Comments in Response to NSPI 4/13/2017 Technical Conference on Future Plan for Thermal Resources

Synapse Energy Economics

April 28, 2017

Reserve Margin Results from Various Candidate Resource Plans – 2014 IRP (“Figure 3. Planning Reserve Margin by CRP”)

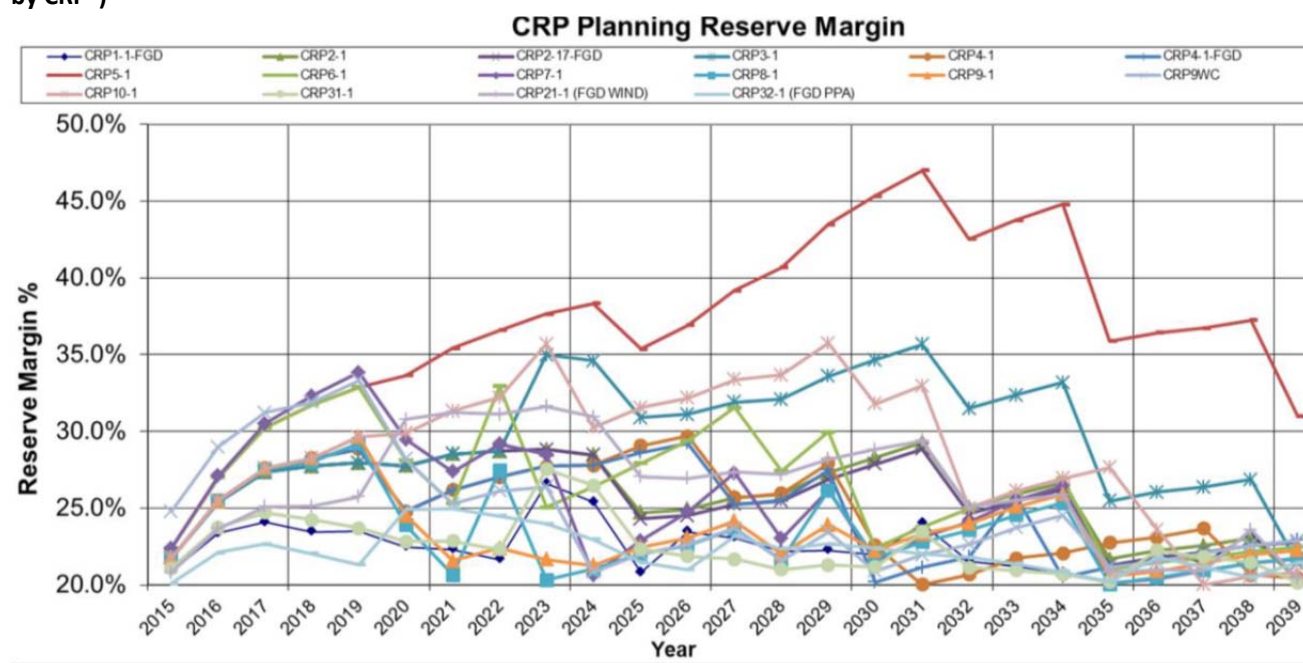
Instead, the 2014 IRP analyses included - *as inputs* - assumptions for sustaining capital costs for each candidate resource plan. The resulting comparison of different plans did not account for the difference in surplus capacity associated with each plan. If the differences were minor, NSPI’s conclusion would not be unreasonable, subject to the certainty of sustaining capital cost assumptions. However, the differences were not minor – the plans with higher levels of peak load reduction resulted in surplus capacity levels that were significantly higher than those associated with lower peak load reduction plans, because no adjustment was made in sustaining capital contribution to allow for retirement of surplus capacity. This is shown in the graph below from the IRP report.

This critical aspect of the 2014 IRP analysis illustrates that NSPI’s conclusion, as re-stated at the 4/13/2017 technical conference, is not well-supported. It is not at all clear that lengthy retention of the coal units was the most economic option arising from the 2014 IRP analysis.²

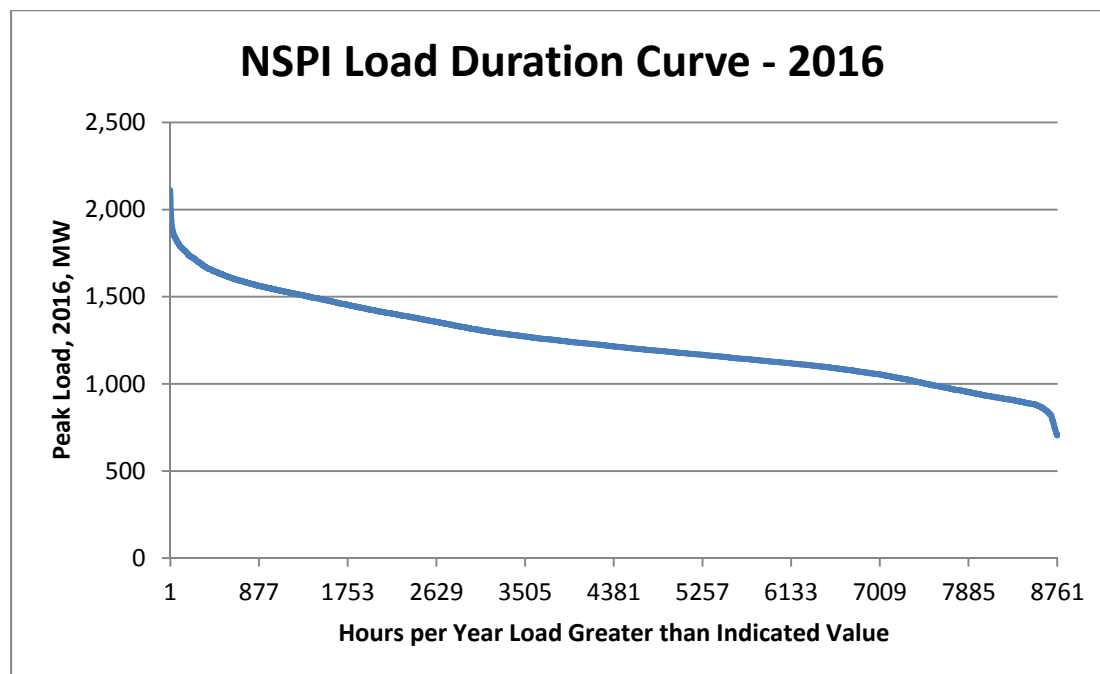
NSPI's need for capacity resources is premised on meeting the peak load. The peak load need exists for a very small fraction of winter hours. In 2016, as in other years, the duration of the highest winter peak loads is infrequent, as seen below in the load duration curve for 2016. To the extent that demand response mechanisms can be incorporated into NSPI's resource base, the need for the last 150 MW – or the last 300 MW – is diminished.
